File Number	PL 21-047	Contact	Kyle Deming, <a href="mailto:kdeming@duluthmn.gov">kdeming@duluthmn.gov</a>	
Type	Special Use Permit – Restaurant	Planning Commission Date		May 11, 2021
Deadline for Action	Application Date	March 26, 2021	60 Days	May 25, 2021
	Date Extension Letter Mailed	April 30, 2021	120 Days	July 24, 2021
Location of Subject		South side of 600 block of W. Central Entrance (Mall Area)		
Applicant	The Parikh Network	Contact	Ed Baksh	
Agent		Contact		
Legal Description		Lot 2, Block 1, Jigsaw Division (010-2589-00020)		
Site Visit Date		April 30, 2021	Sign Notice Date	April 27, 2021
Neighbor Letter Date		April 30, 2021	Number of Letters Sent	18

A 2,287 sq. ft. restaurant with drive-through and 24 parking spaces located in the Jigsaw Division.

PL 21-047  
600 Block of  
W. Central Entrance  
Special Use Permit -  
Restaurant in MU-N

SHEET NO.  
C200

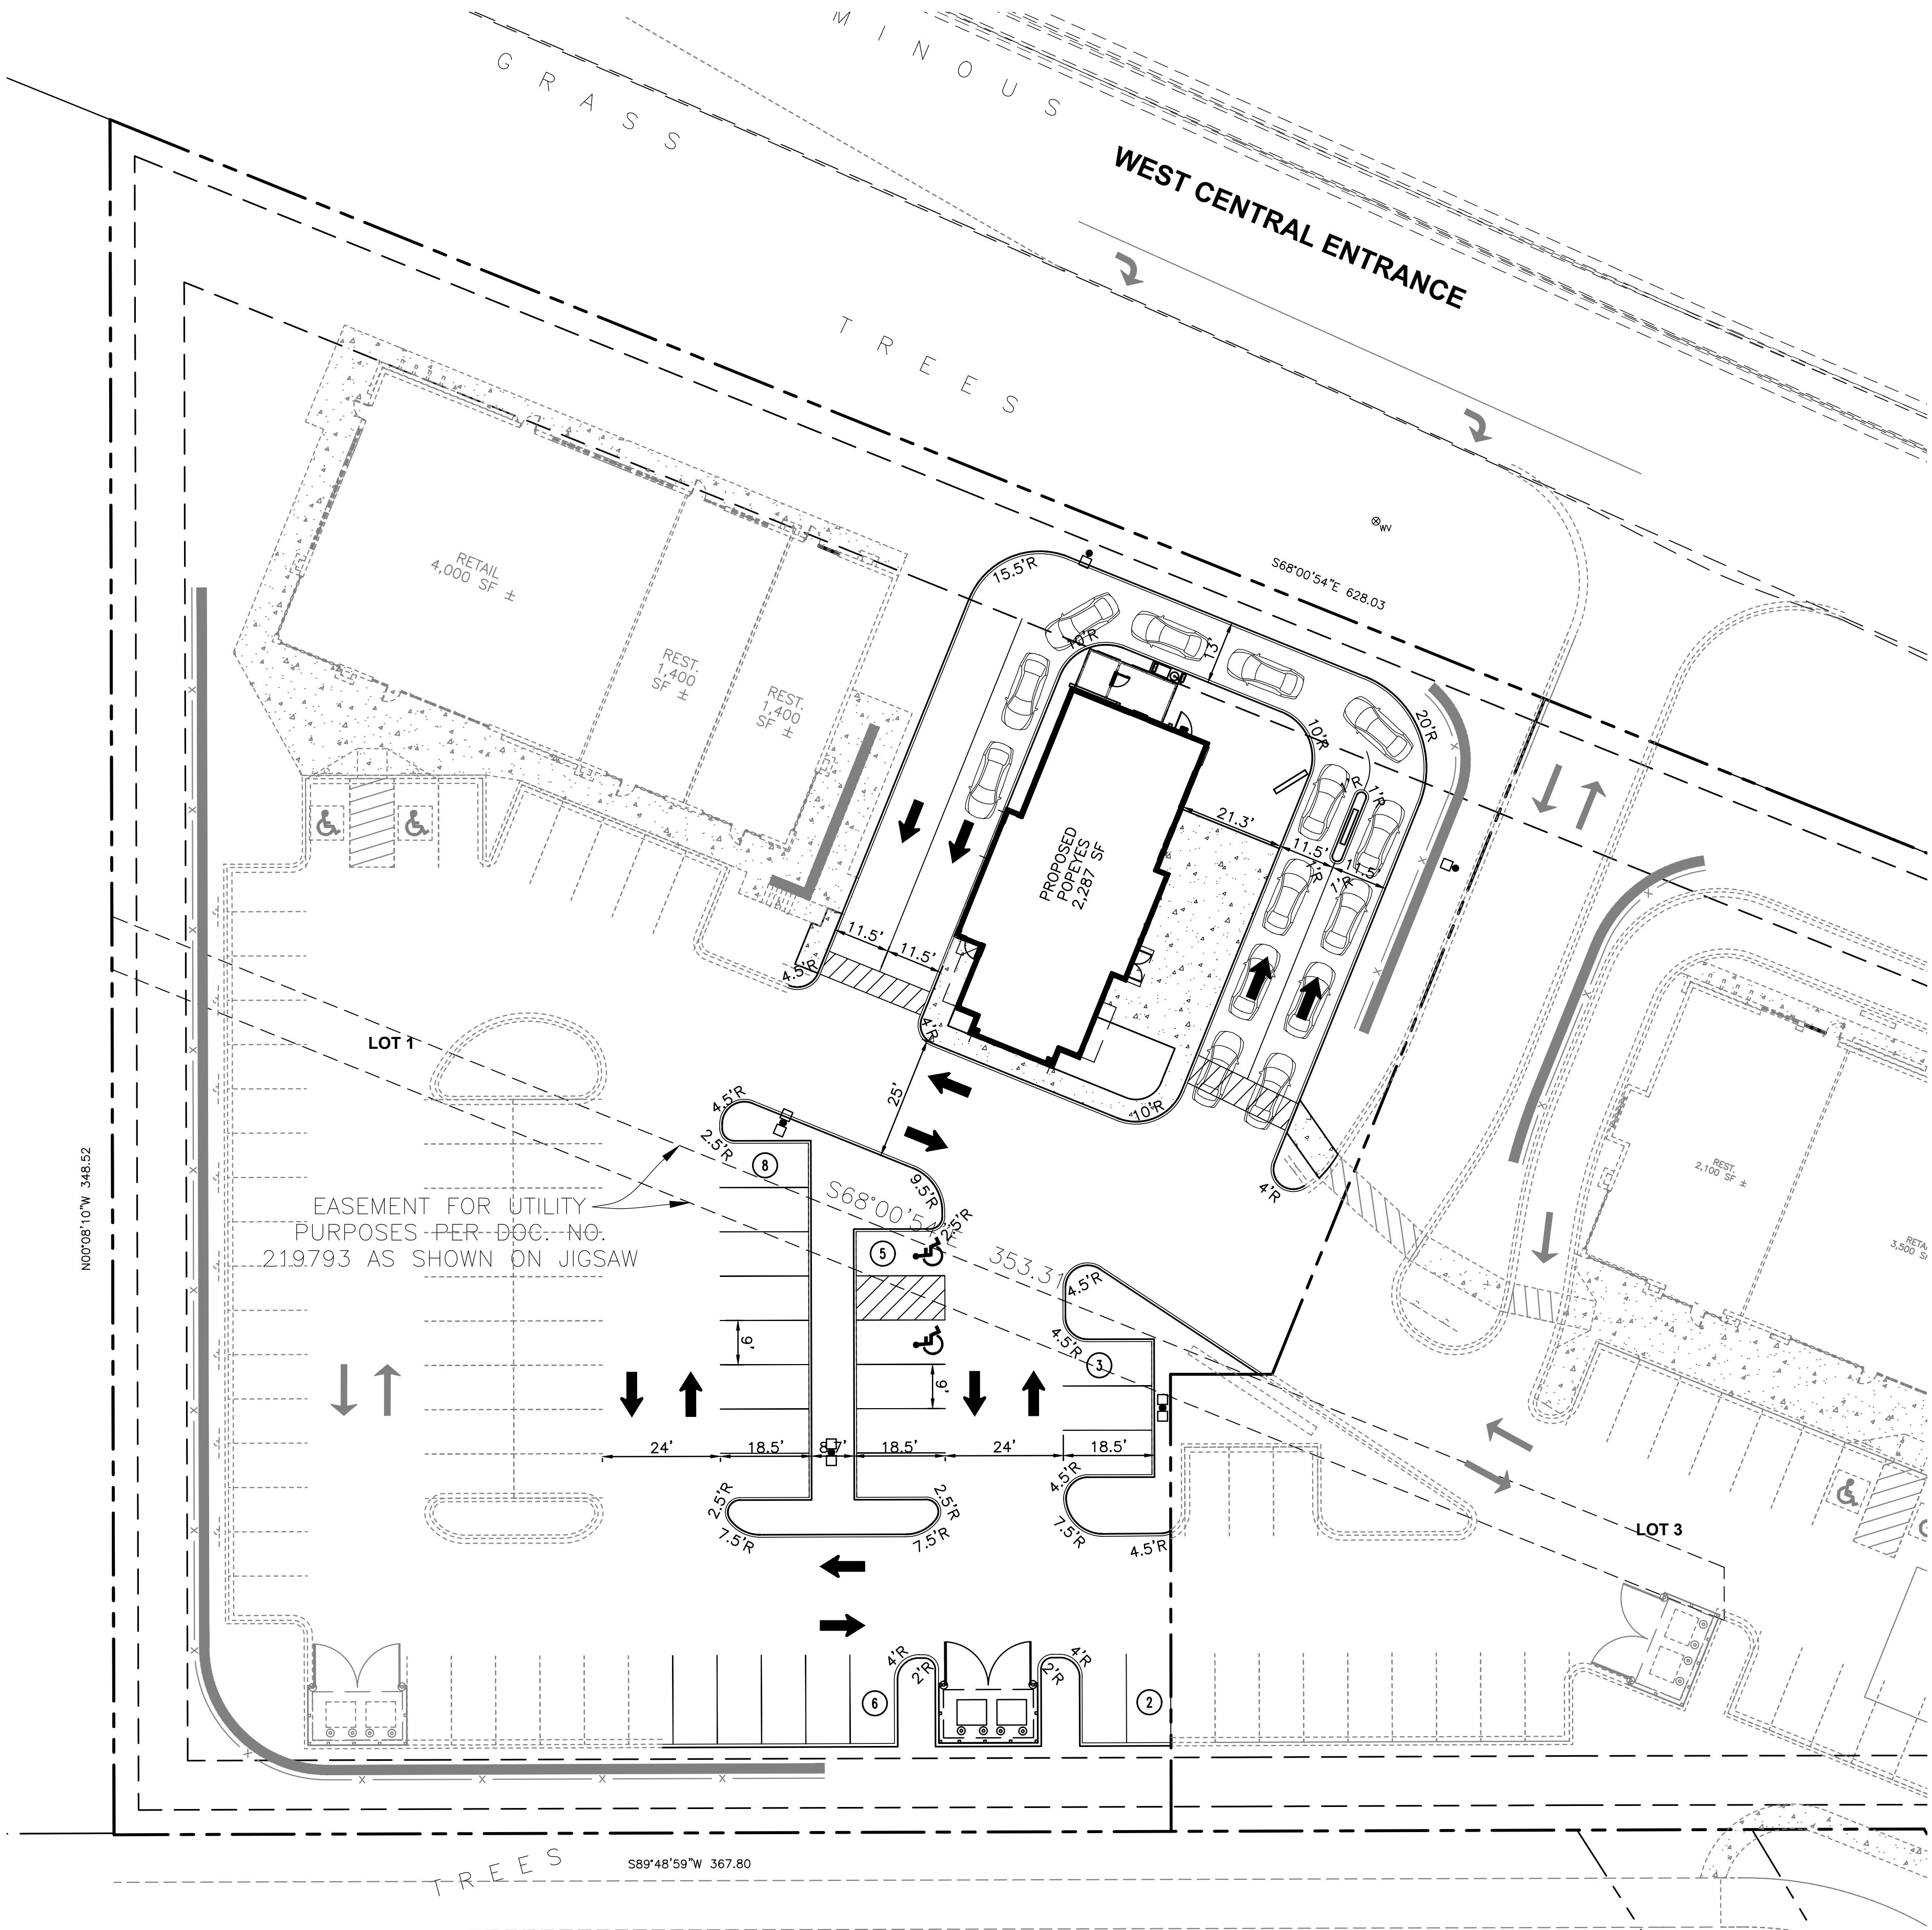
2. Applicant is proposing a 2,287 sq. ft. restaurant with a drive through window that has 2 lanes for ordering. There is room for 6 vehicles to cue up at the menu/ordering station, which complies with UDC requirements of space for 5 vehicles to cue up. Applicant will need to modify the site plan to comply with UDC requirements limiting to a single drive through lane and speaker box.

4. The Woolpert site plan shows 24 parking spaces and the Launch Properties preliminary site plan shows 28 spaces. The maximum allowed (150% of minimum) is 22 spaces. Therefore, staff recommends a condition of approval be the applicant reduce parking to 22 spaces.

7. HVAC mechanical units are not shown and will need to be screened from view, which will need to be verified at time of building permit application.
8. Trash screening is provided on both site plans and materials used will need to be verified for compliance at time of building permit. The location should be at the end of a drive aisle to facilitate access by the trash hauler.

- 3) Applicant provide details about construction of storm water facilities sufficient to meet City requirements as verified by the City Engineer.
- 4) Reduce the number of drive through speaker boxes to and ordering lanes to 1.

- 5) Reduce the number of vehicle parking spaces to 22.
- 6) Applicant provide a landscape plan based on the final site plan that shows landscape islands a minimum width of 8 feet and tree cover to meet the 30% parking lot coverage requirement.

- 7) Relocate trash enclosure to line up with a drive aisle to facilitate access by the trash hauler and provide details about the construction materials.

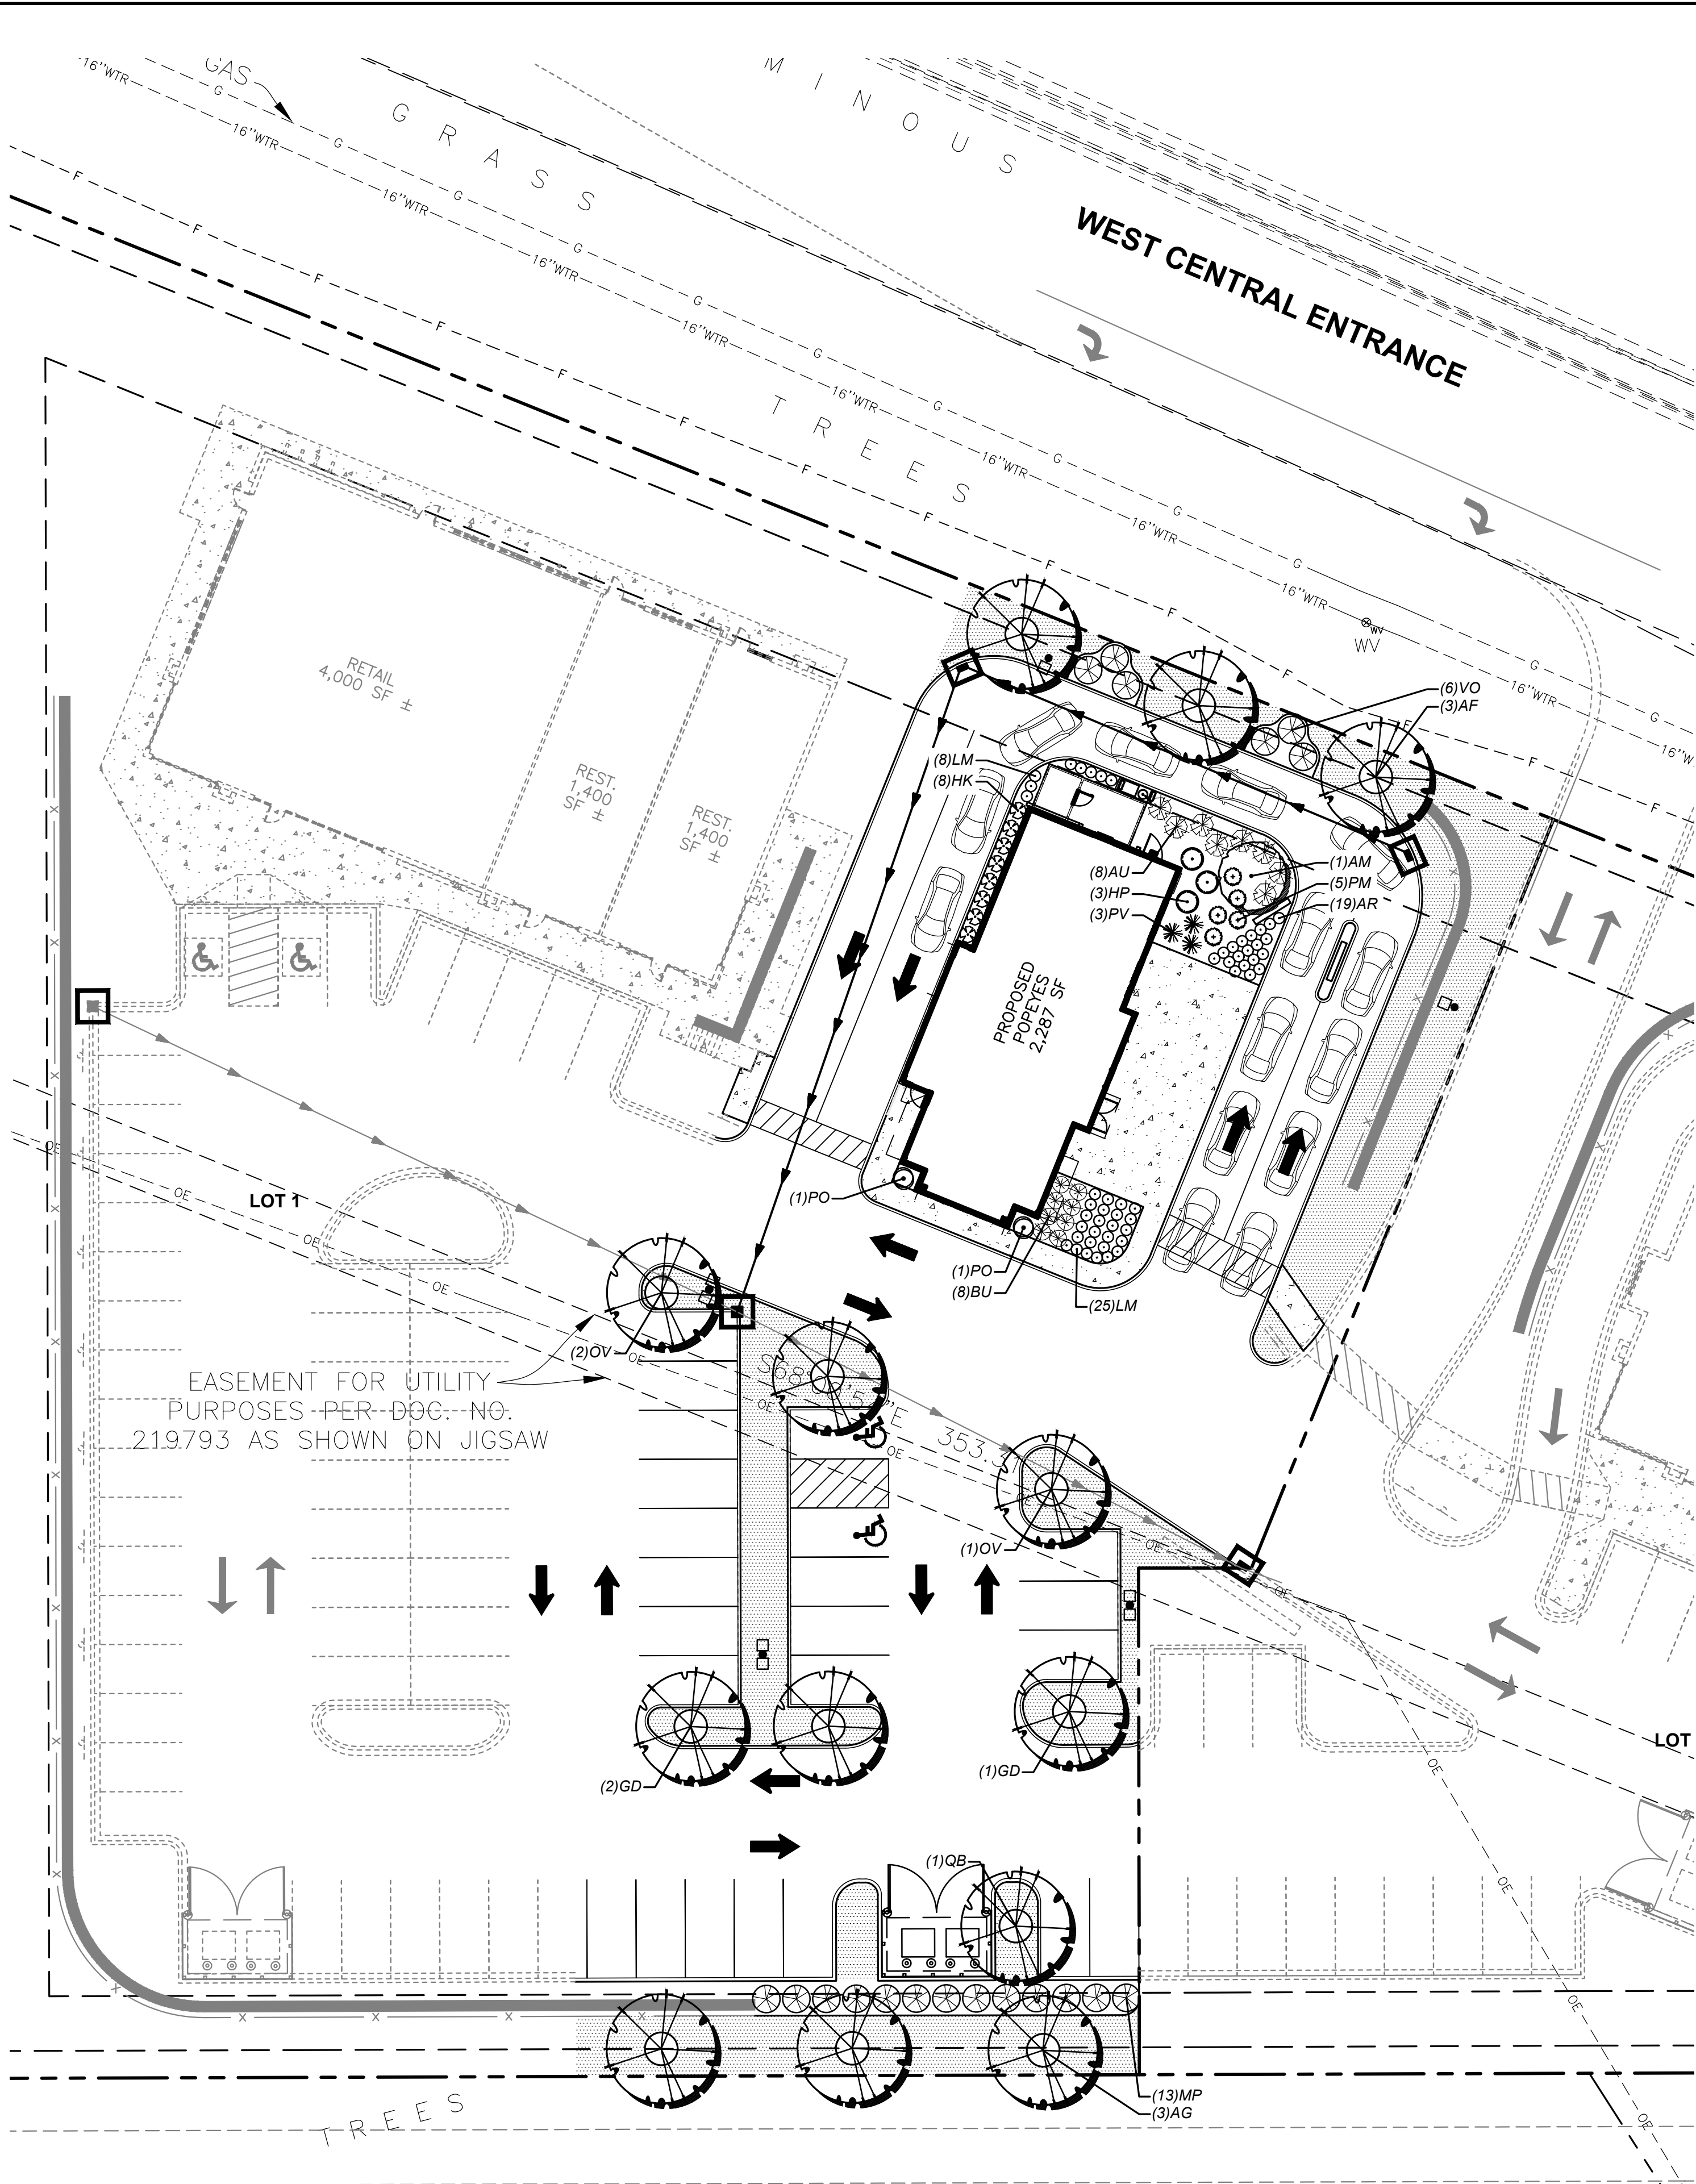
5. One or more of the landscape islands appear to be less than 8 feet wide on both the Woolpert and Launch Properties site plans. Therefore, staff recommends a condition that they be increased to at least the minimum width to allow space for the root systems of trees planted.

6. The landscape plan submitted matches the Woolpert site plan, but does not match the Launch Properties preliminary site plan. Applicant must submit a landscape plan that matches the selected site plan and that it shows calculation of the required 30% tree canopy coverage.
